DA NO: DA-2022/393

ADDRESS: 3 ELLIS STREET, CHATSWOOD NSW 2067.

PROPOSAL: DEMOLITION OF EXISTING RESIDENTIAL UNIT BUILDING, CONSTRUCTION OF A 14 STOREY SHOP TOP HOUSING DEVELOPMENT COMPRISING 3 STOREYS OF RETAIL/COMMERCIAL USE, COMMUNAL FACILITIES AND 4 LEVELS OF BASEMENT CAR PARKING, LANDSCAPING AND ASSOCIATED WORKS

REPORT DATE: 19 APRIL 2024

Figure 1: Subject site – Height Standard (Clause 4.3 WLEP2012)

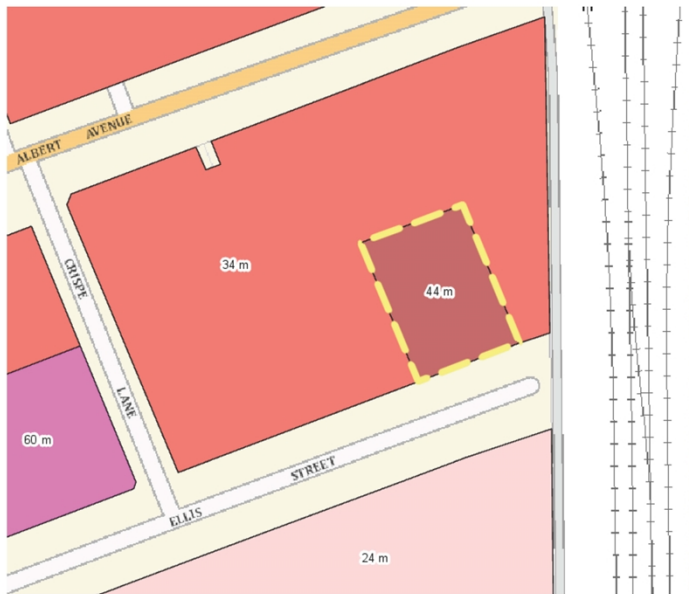
- Clause 4.3 (Height of Buildings) – which permits a maximum Height of Buildings of 44m
Refer to Figure below.

Description of non compliance

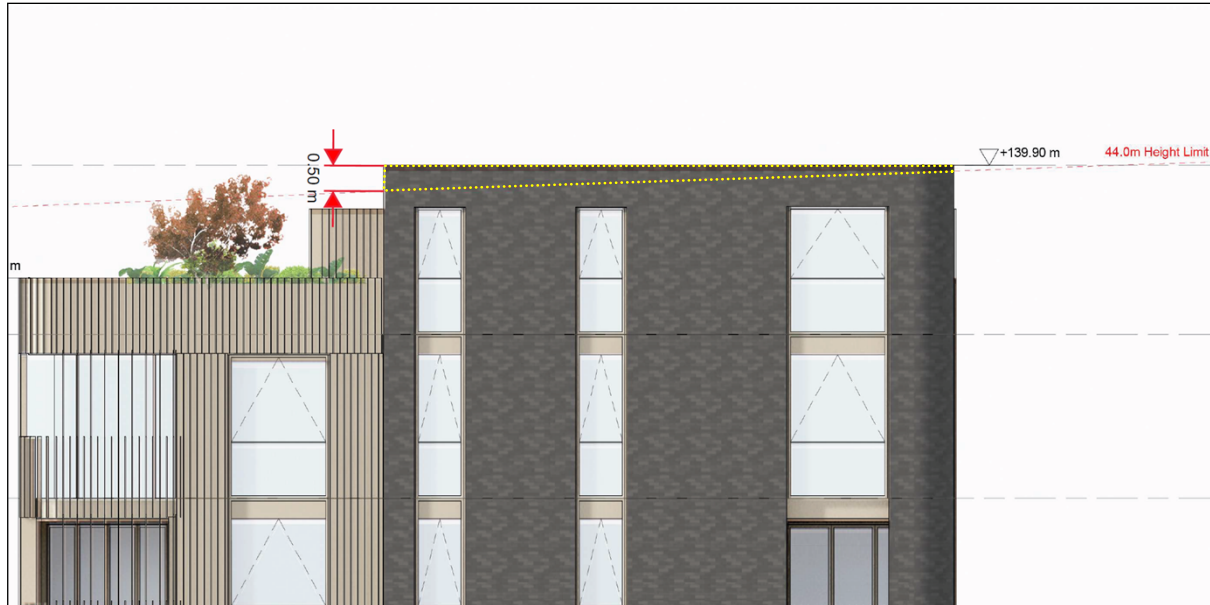
Development Standard	Height Standard	Proposed Height	%Variation
CI 4.3 Height of buildings	44m	44.5m indicated by the applicant.	1.14% 0.5m over the standard

- i) The development breaches the height control as a consequence of the increased floor-to floor heights required for non-residential uses on the podium levels of the building.
- ii) The variation is minor and will not be visible or discernable from adjacent properties or the public domain.
